RESOLUTION NO. PZ 16-18
Series of 2018

A RESOLUTION BY THE PLANNING AND ZONING COMMISSION OF THE TOWN OF DILLON, COLORADO, RECOMMENDING THE APPROVAL OF THE SIGN PLAN FOR THE DILLON HOMEWOOD SUITES PUD DEVELOPMENT PLAN LOCATED AT 122 LAKE DILLON DRIVE; AND, SETTING FORTH DETAILS IN RELATION THERETO.

**PLANNING AND ZONING COMMISSION ACTION ITEM
STAFF SUMMARY
SEPTEMBER 5, 2018 PLANNING AND ZONING COMMISSION MEETING**

EAST ELEVATION (MAIN ENTRY)

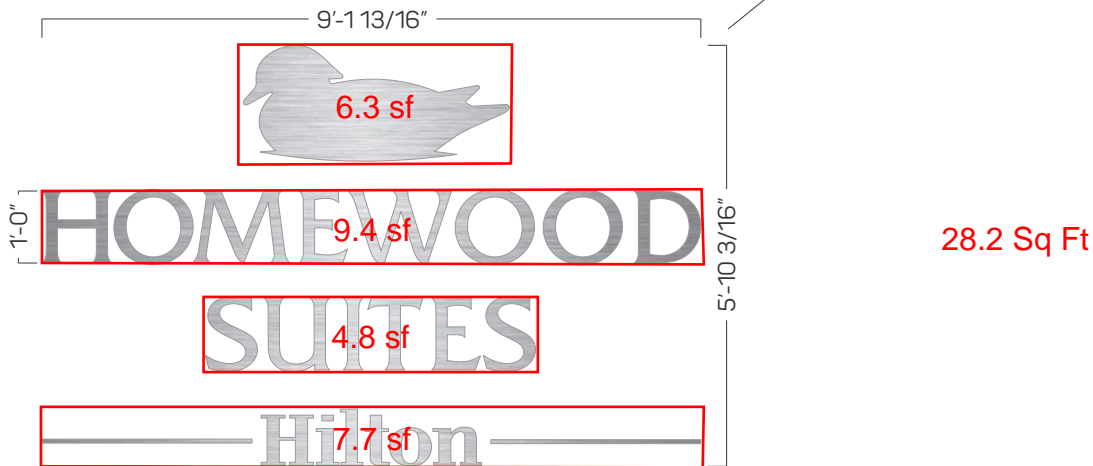
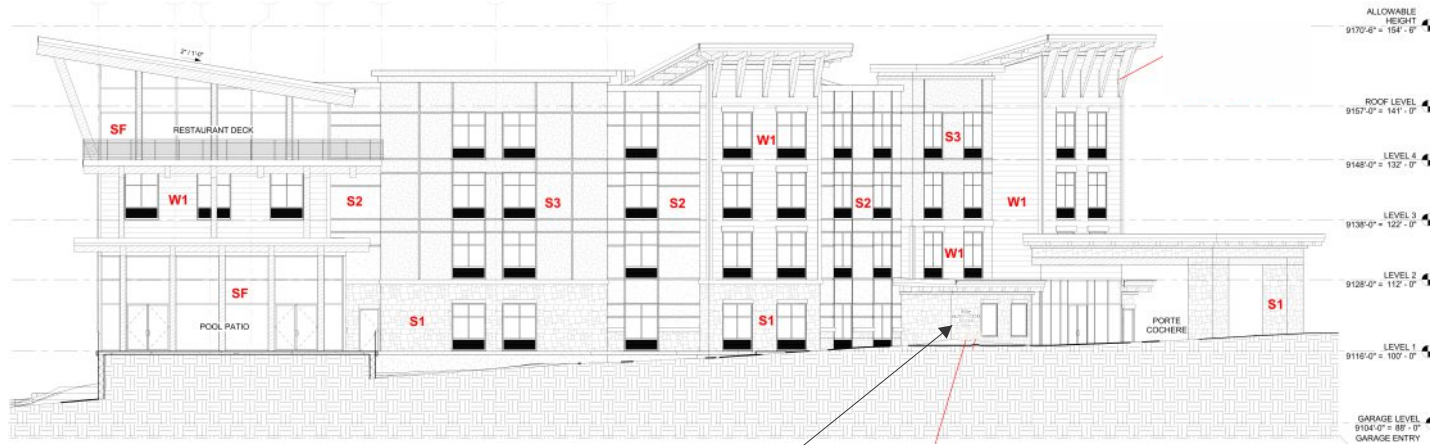
- b. **SIGN 2:** Twenty-Eight and two tenths (28.2) square foot Building Identification Sign near the front entrance to the hotel on the first (1st) level. This sign shall be Soffit illuminated from above and set on the building wall near the front entrance to the building at the Porte Cochere.

SOUTH WEST ELEVATION (STAIR CORE SIGN)

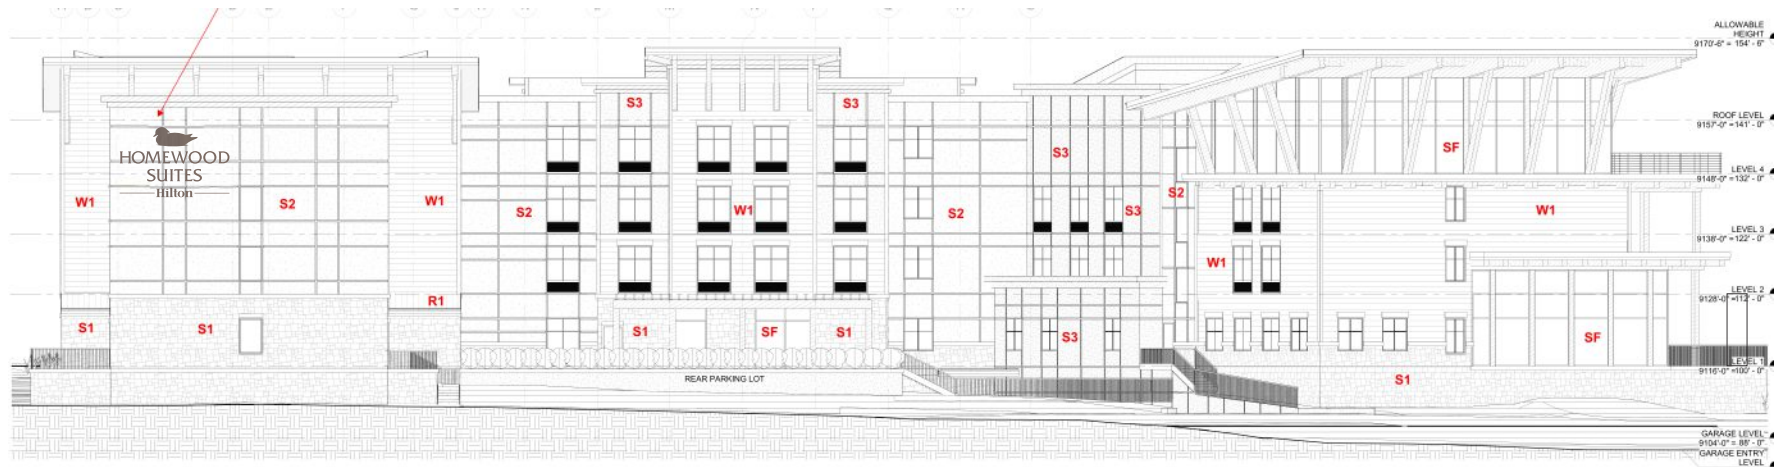
- c. **SIGN 3:** One Hundred Fourteen and seven tenths (114.7) square foot Building Identification Sign on the southwestern face of the hotel building overlooking eastbound US Highway 6 on the fourth (4th) level overlooking the intersection of US Highway 6 and Lake Dillon Drive. This sign shall be Halo back-lit brushed stainless-steel or deep fabricated dark oxidized bronze graphics building wall signs overlooking US Highway 6.

HWY 6 SIDE ELEVATION

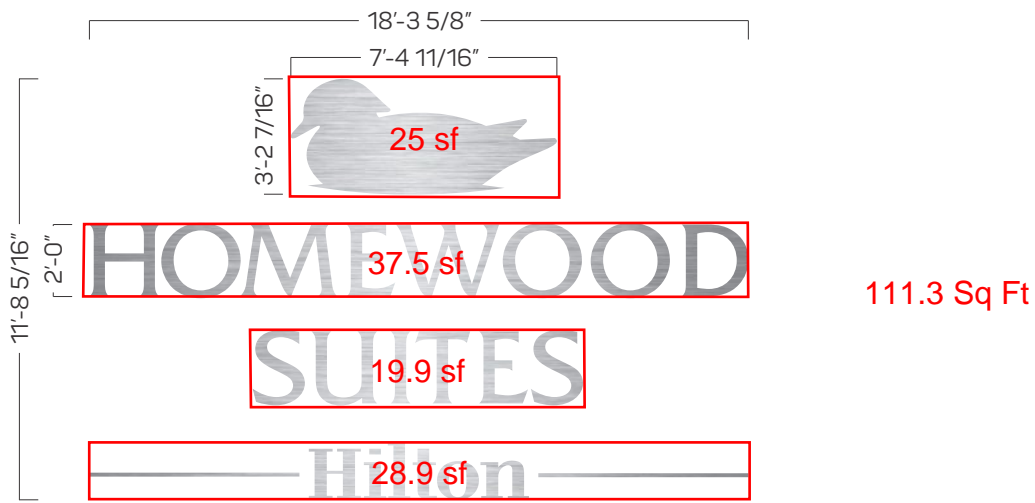
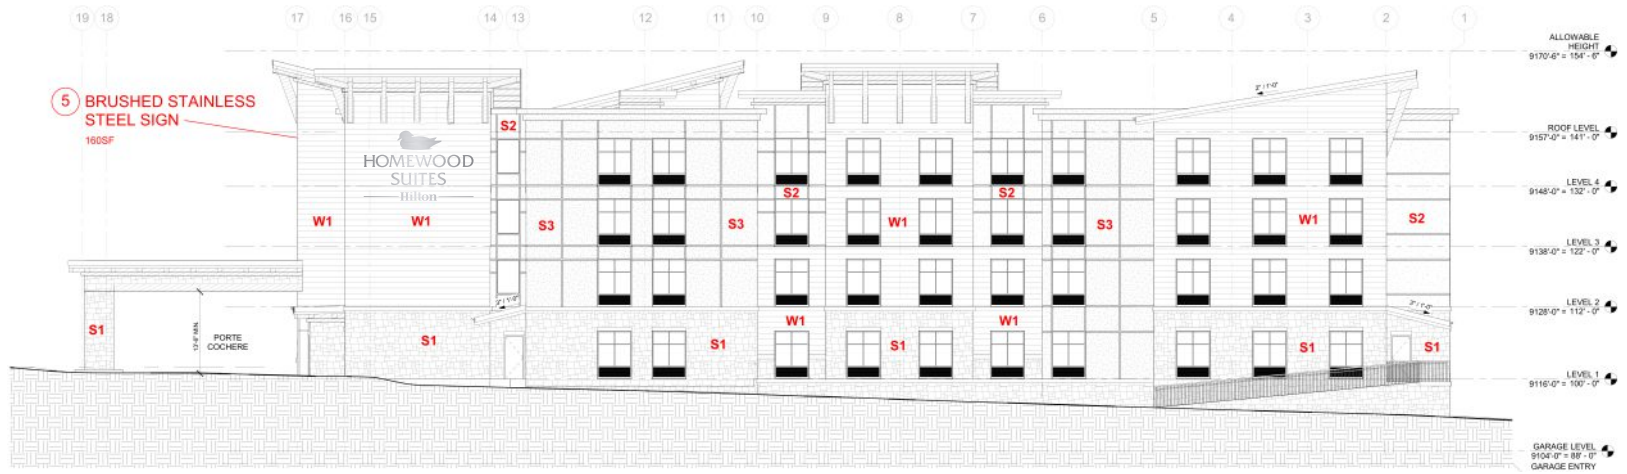
- d. **SIGN 4:** One-Hundred-Eleven and three tenths (111.3) square foot Building Identification on the northern face of the hotel on the fourth (4th) level overlooking the intersection of Lake Dillon Drive and US Highway 6. This sign shall be Halo back-lit brushed stainless-steel or deep fabricated dark oxidized bronze graphics building wall signs overlooking US Highway 6.

MONUMENT SIGN DETAIL
 BOXED AREA: 9.51 SQ. FT.
 SCALE: 3/4" = 1'-0"

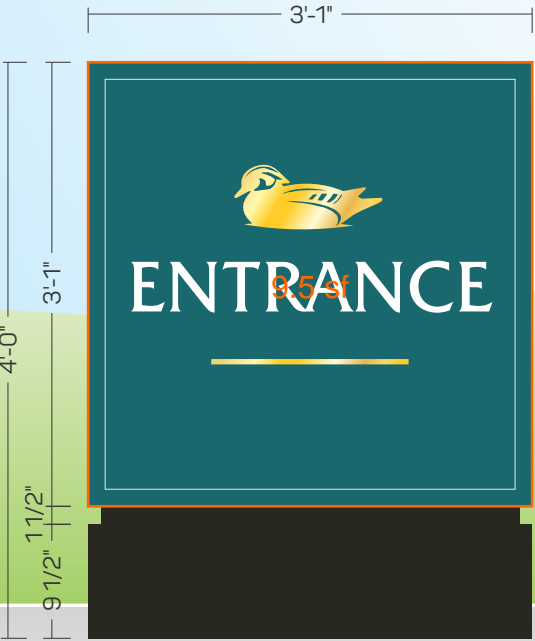
- e. **SIGN 5:** Nine and five tenths (9.5) square foot Freestanding Directory Sign near the intersection of Lake Dillon Drive and the 40’ Right of way. This sign shall be Internally illuminated.
